**BOARD OF COUNTY COMMISSIONERS  
ORANGE COUNTY, FLORIDA**

**ADDENDUM NO. 3 / IFB NO. Y18-729-TA**

**SOUTH WATER RECLAMATION FACILITY INFLUENT PUMP STATION  
IMPROVEMENTS**

SCALE: NOTED  
 DRAWING NO.: M16  
 SHEET: 80 OF 123

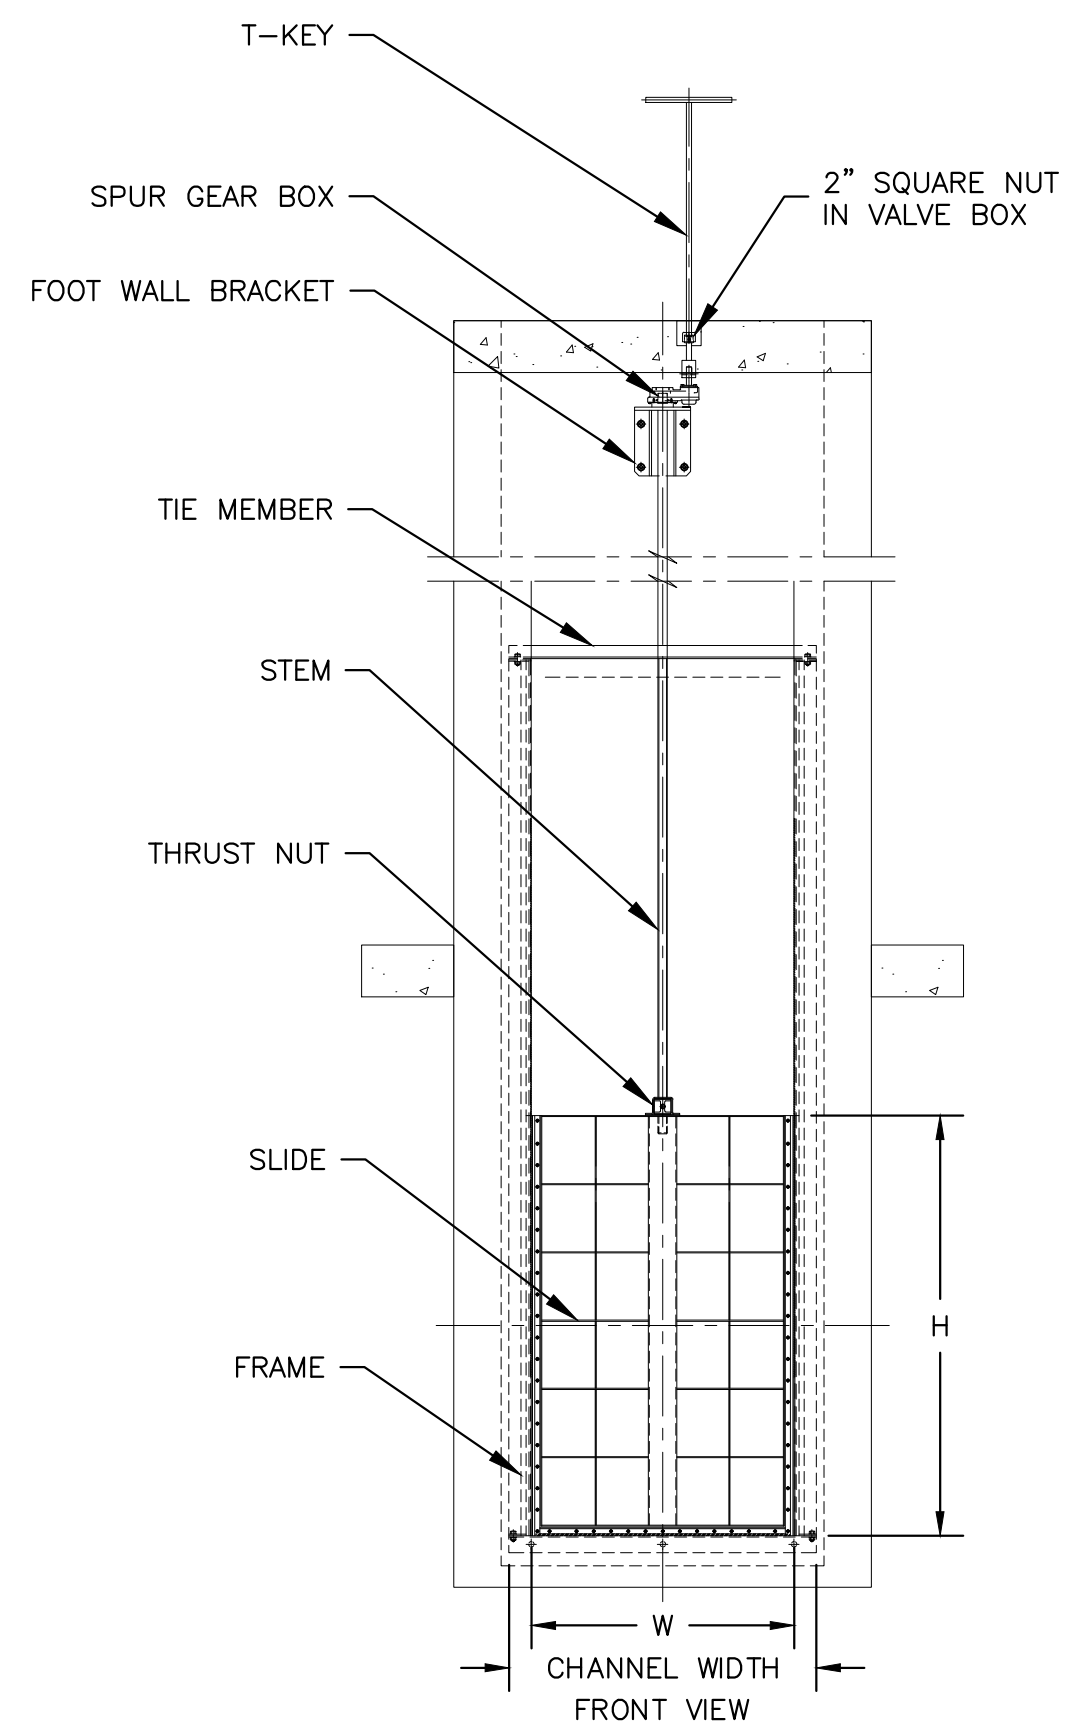
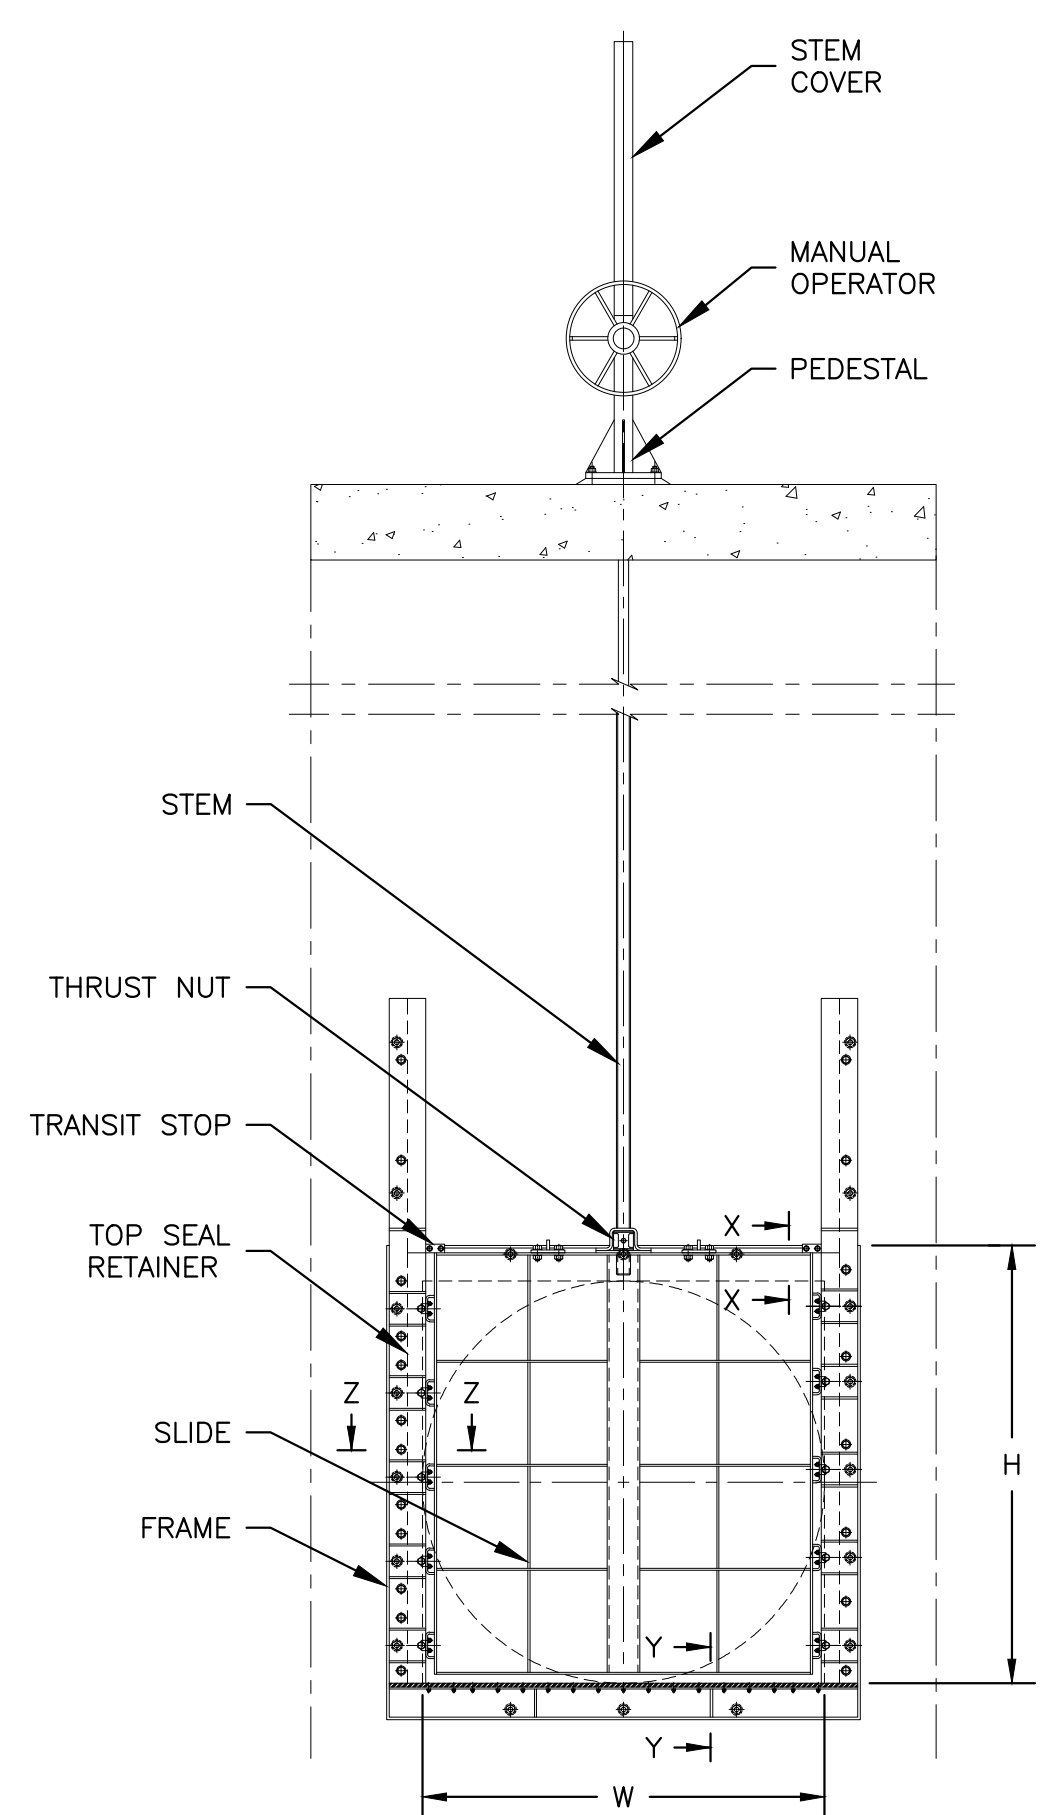
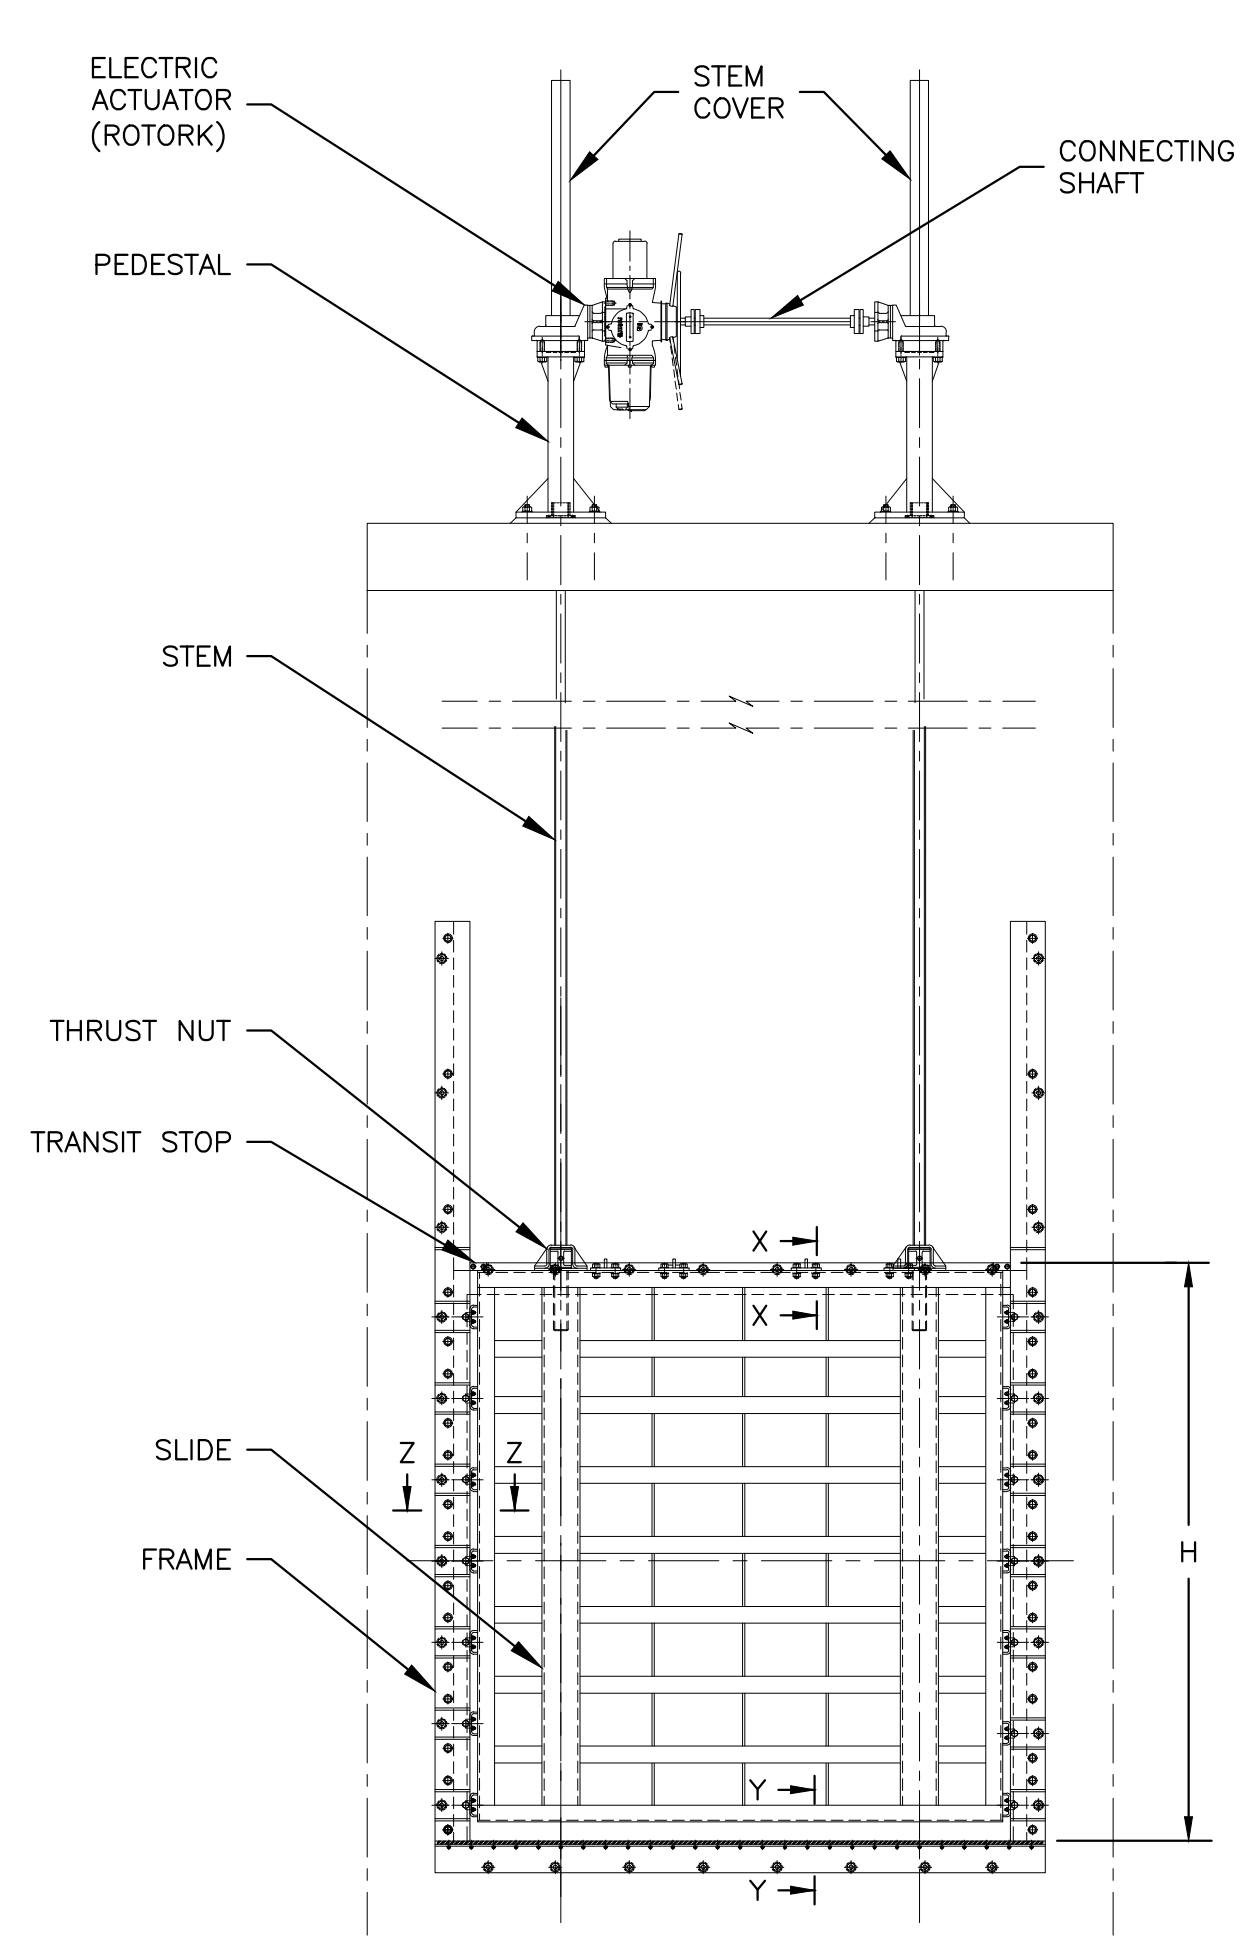
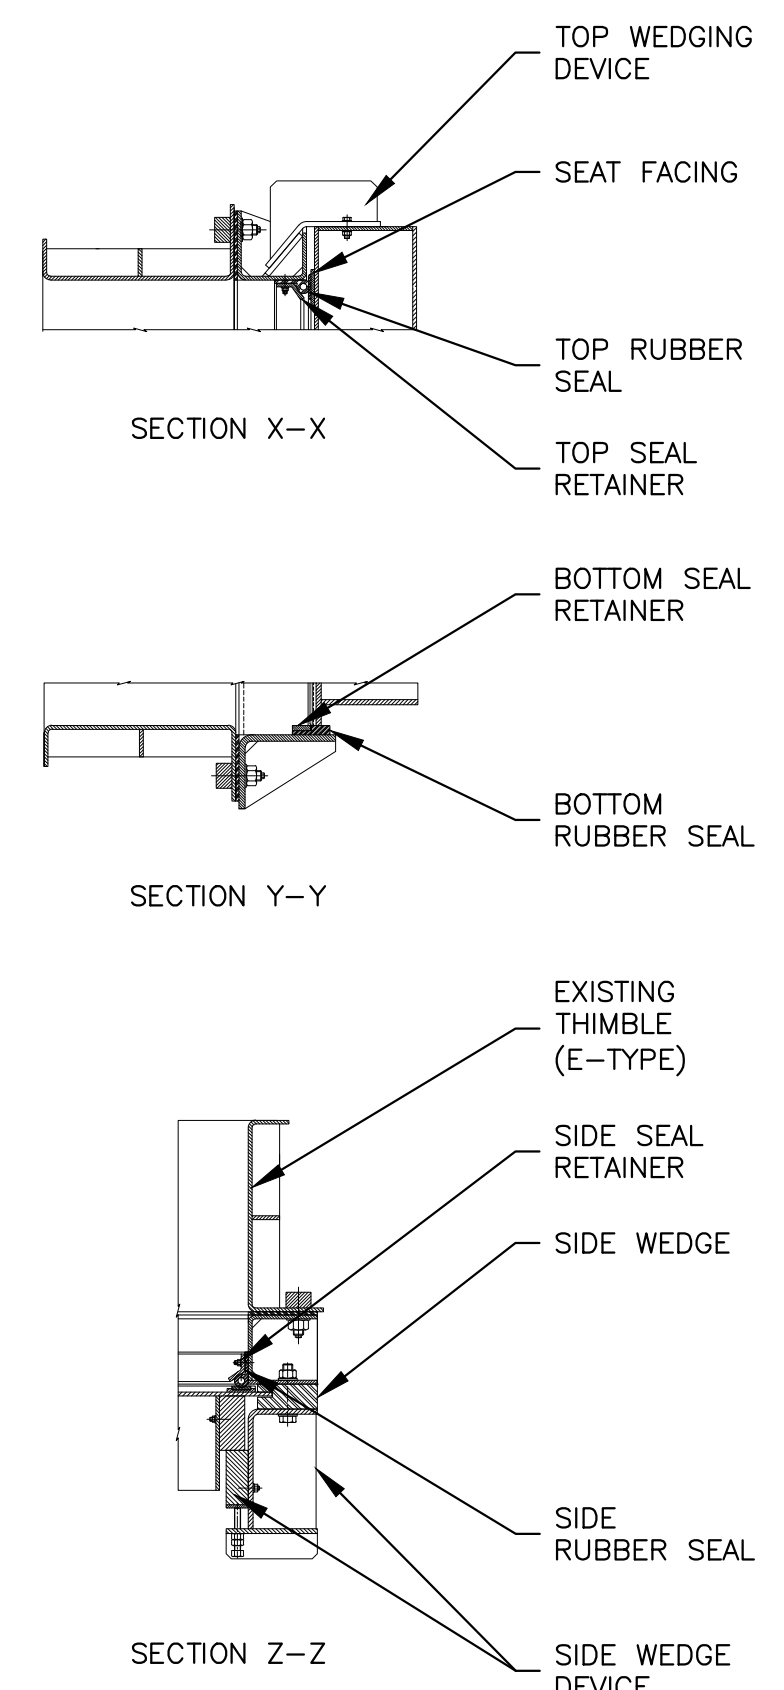
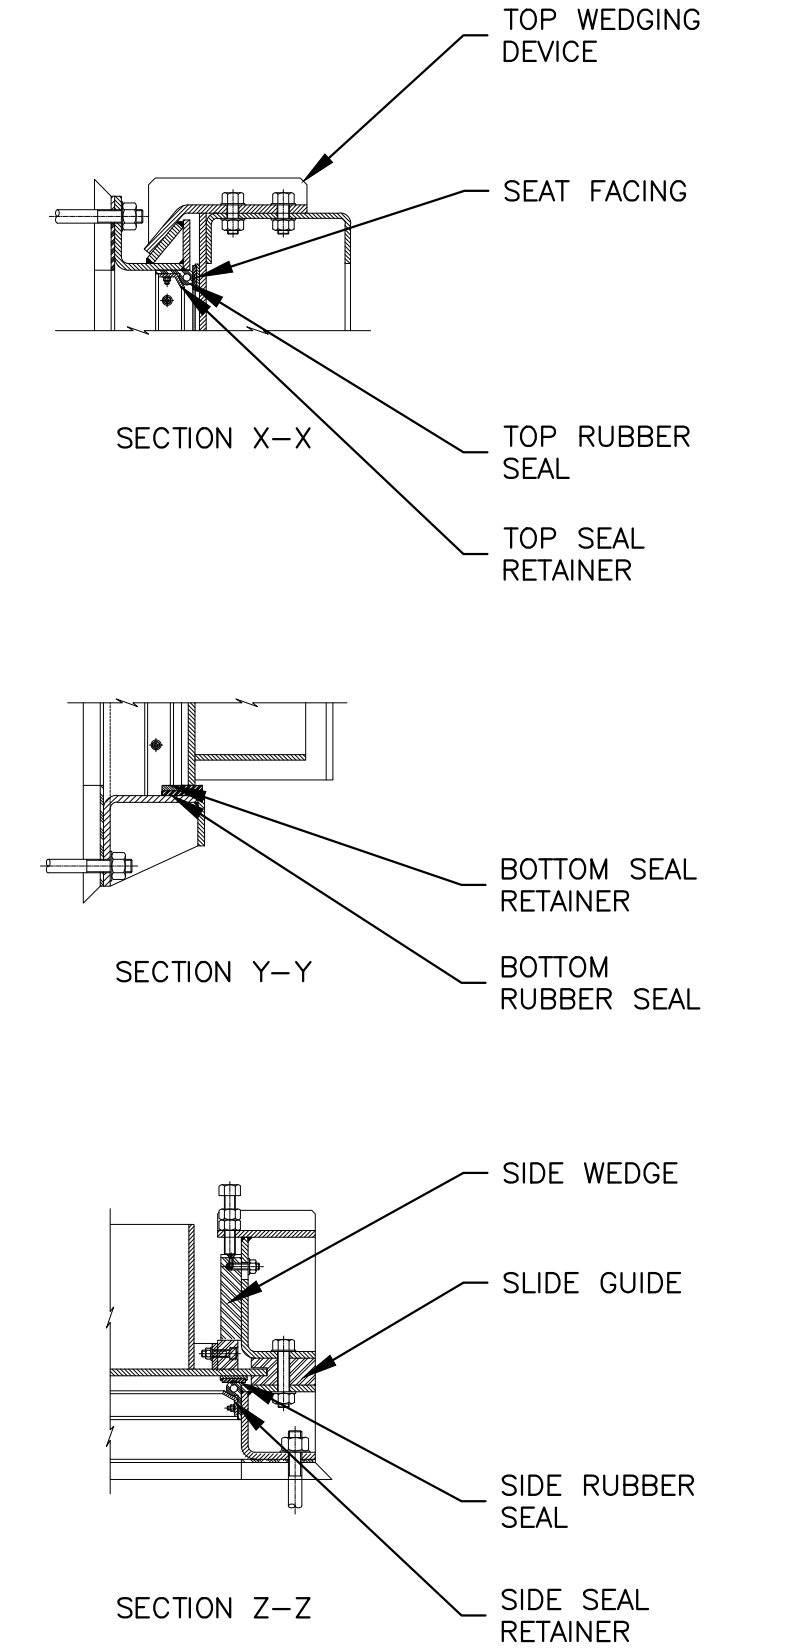
**20. Q. The stainless steel slide gate schedule (Table 11201-1) at the end of specification section 11201 lists gates SG-16, 17, 26, 27, 28 as EMF (Embedded Frame, Sides and Bottom). These gates are shown at the existing Influent Pump Station on drawings M12 and M13 to be installed in existing concrete walls. Please confirm that saw-cutting and chipping out the existing concrete walls and floor will be required to install these gate frames, or if wall mounted frames can be supplied to be installed on the face of the existing concrete walls.**

4. Drawing S18 be deleted in its entirety and replaced with the attached Revised S18 drawing.
5. Drawing M06 – Delete note 2 in its entirety and replace with “2. PIPES THROUGH CONCRETE WALLS PER PIPE PENETRATION DETAIL C ON SHEET M-17.”
6. Drawing M07 to be deleted in its entirety and replaced with the attached Revised M07 drawing.
7. Drawing M08 to be deleted in its entirety and replaced with the attached Revised M08 drawing.
8. Drawing M09 be deleted in its entirety and replaced with the attached Revised M09 drawing.
9. Drawing M15 be deleted in its entirety and replaced with the attached Revised M15 drawing.
10. Drawing M16 to be deleted in its entirety and replaced with the attached Revised M16 drawing.

A. The stainless steel gate schedule has been revised to address installation requirements.
